FRANKLIN CITY HALL CHAMBERS  
9229 W. LOOMIS ROAD  
FRANKLIN, WISCONSIN

**PLAN COMMISSION MEETING AGENDA**  
**Thursday, August 22, 2024 at 6:00 P.M.**

CITY OF FRANKLIN  
REPORT TO THE PLAN COMMISSION  
Meeting of August 22, 2024  
SPECIAL USE & SITE PLAN

A RESOLUTION APPROVING A SITE PLAN FOR TSUNAMI EXPRESS CAR WASH,  
A CARWASH FACILITY  
(6449 S WHITNALL EDGE ROAD)  
(TSUNAMI EXPRESS CAR WASH, APPLICANT)

**Figure 11: Sound Contour Map – Tsunami Car Wash with 8-ft Property Line Barrier (Darkest Red Shaded Areas exceed the Ordinance)**

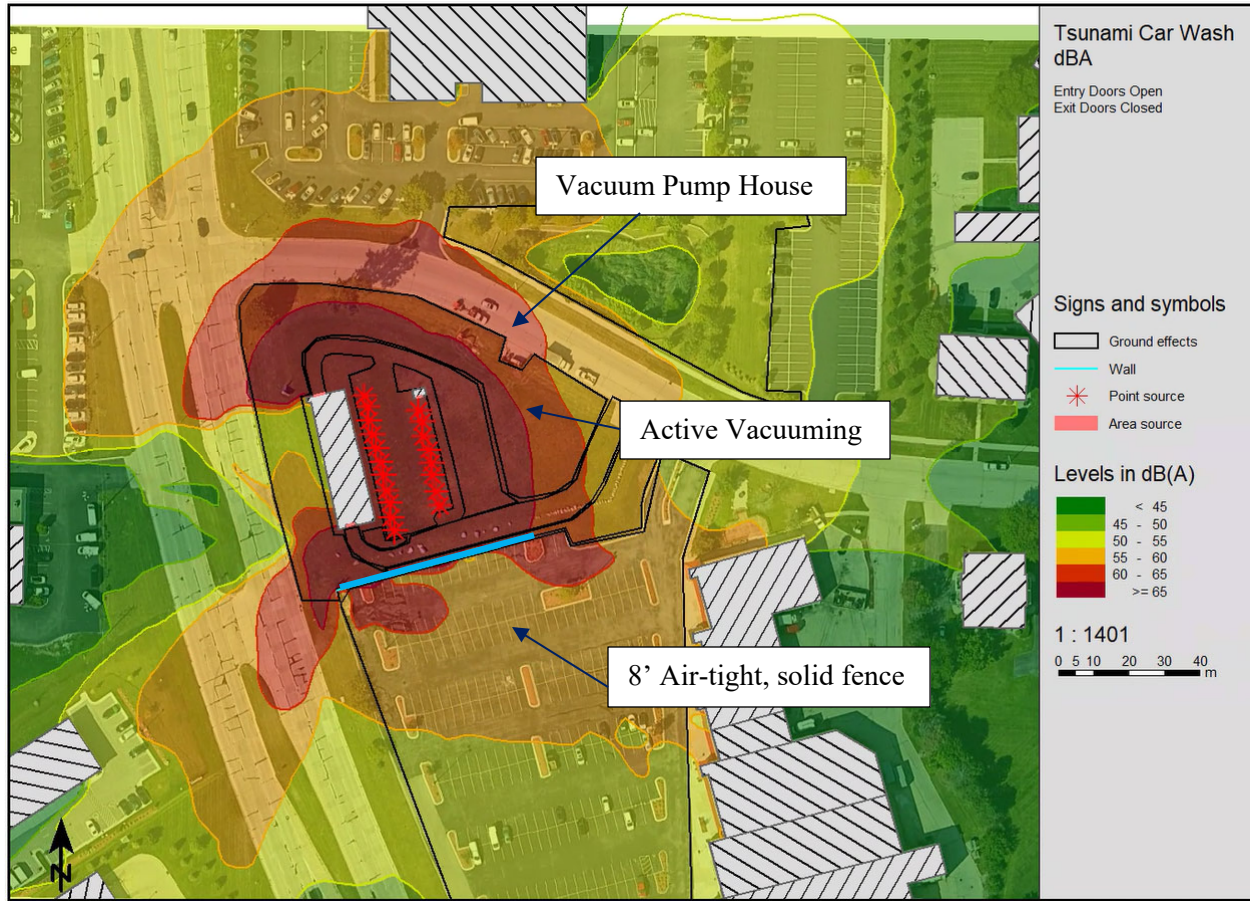
To prevent the sound level from exceeding the 65 dBA noise ordinance at the property line, install an 8' sound barrier along the south border. Refer to Figure 11 for barrier extent and predicted sound levels. A solid, air-tight construction of the sound barrier walls with a face weight that is greater than or equal to ¾" plywood is required.

**TSUNAMI EXPRESS CAR WASH**  
DIMENSIONED SITE PLAN  
FOR  
TSUNAMI EXPRESS CAR WASH FRANKLIN, LLC.  
CITY OF FRANKLIN, COUNTY OF MILWAUKEE, WISCONSIN

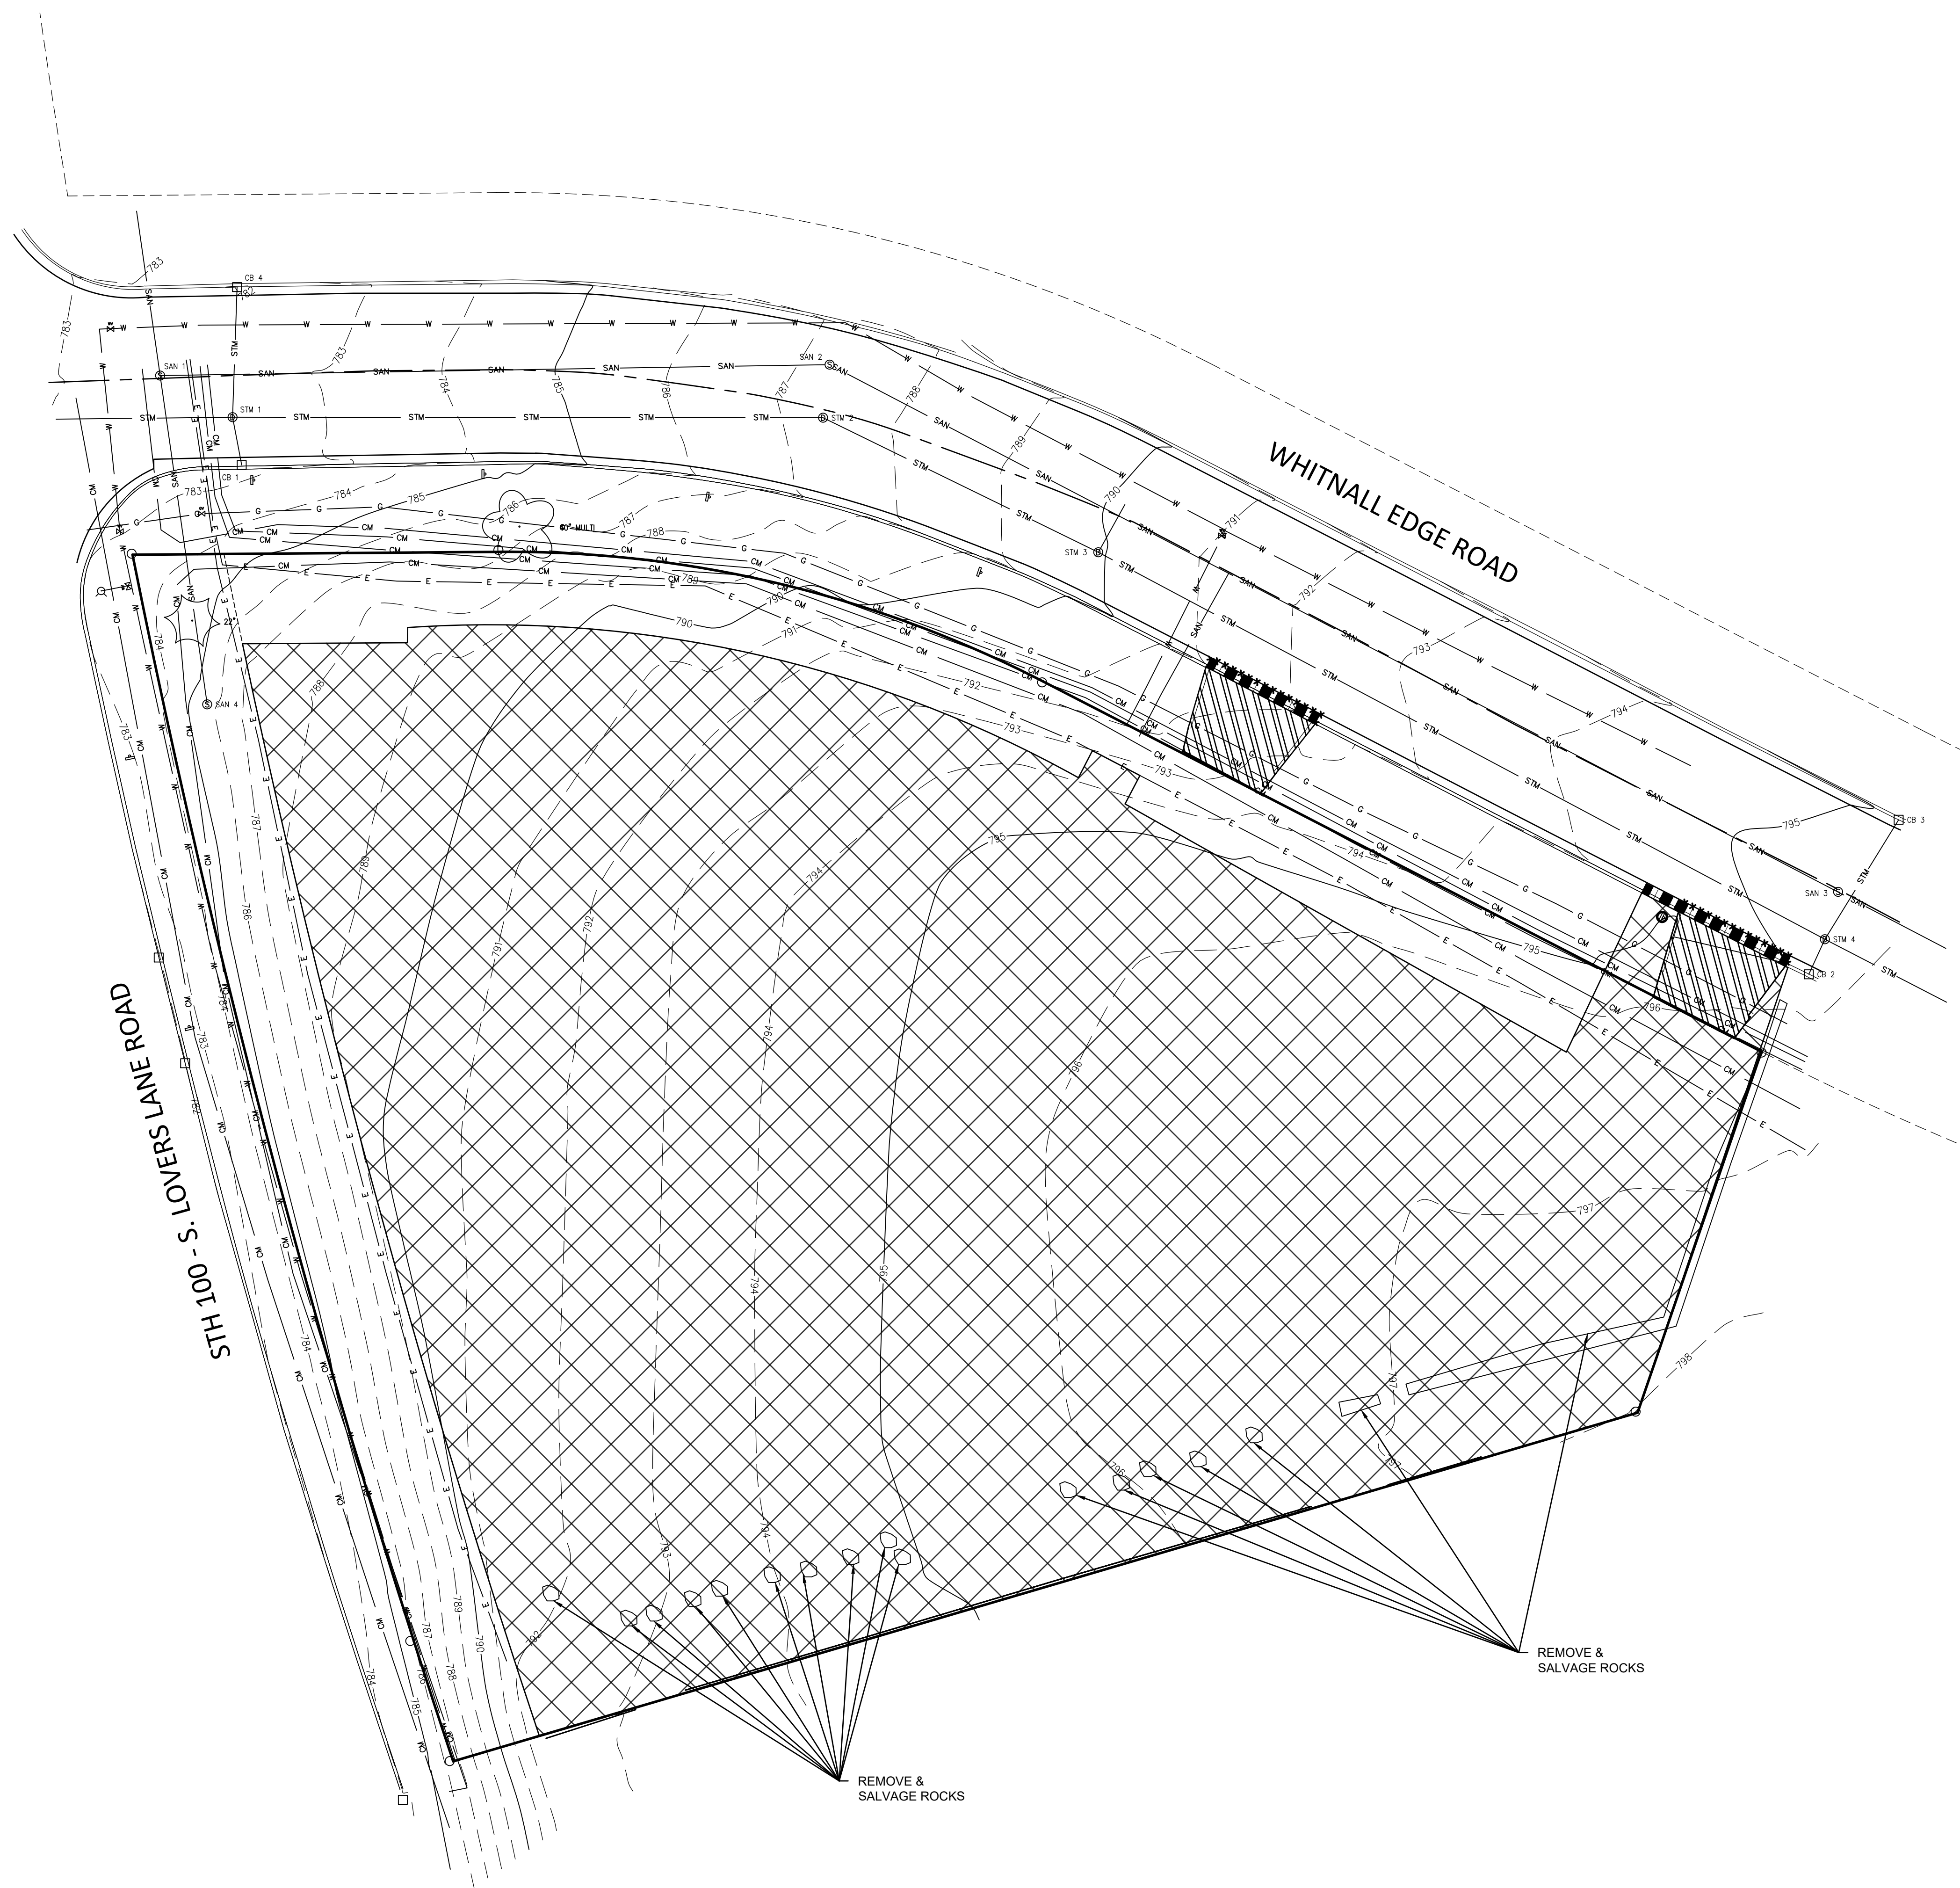
8. **ADA parking.** The architectural site plan depicts one space for ADA parking (Americans with Disabilities Act) but the pavement grading plan (sheet C-7) depicts two ADA parking spaces, please clarify. Note that for this site, one ADA parking space is sufficient per UDO Table 15-5.0202(I)(1). The minimum dimensions for ADA parking are 13 feet wide by 20 feet long, the proposed ADA parking space is 18 feet long, please revise.

9. **Minimum distance of required concrete curbing from property lines.** Even though the architectural site plan depicts the required 10-foot separation from the drive to the south property line, this distance must be measured from the back of curb per UDO §15-5.0202.E.2. This distance is less than 10 feet in the pavement grading plan (sheet C-7), please revise accordingly.

The building has been adjusted to comply with the setbacks as shown on sheet C-3 and architectural site plan on AS-100 in the revised drawing packet.

The drive has been adjusted to not encroach into the utility easement as shown on Sheet C-3 in the revised drawing packet.

Parking sizes have been adjusted to meet the minimum size standards as shown on Sheet C-3 in the revised drawing packet.

Civil plans have been updated to reflect one ADA parking stall. Plans have also been updated for ADA parking stall to be 20' in length as shown on Sheet C-3 in the revised drawing packet.

The pavement has been adjusted to comply with this standard as shown on Sheet C-3 in the revised drawing packet.

The width of the parking lot has been increased to meet the 65' minimum as shown on Sheet C-3 in the revised drawing packet.

Snow storage shall be in the detention basin as noted on Sheet C-3 in the revised drawing packet.
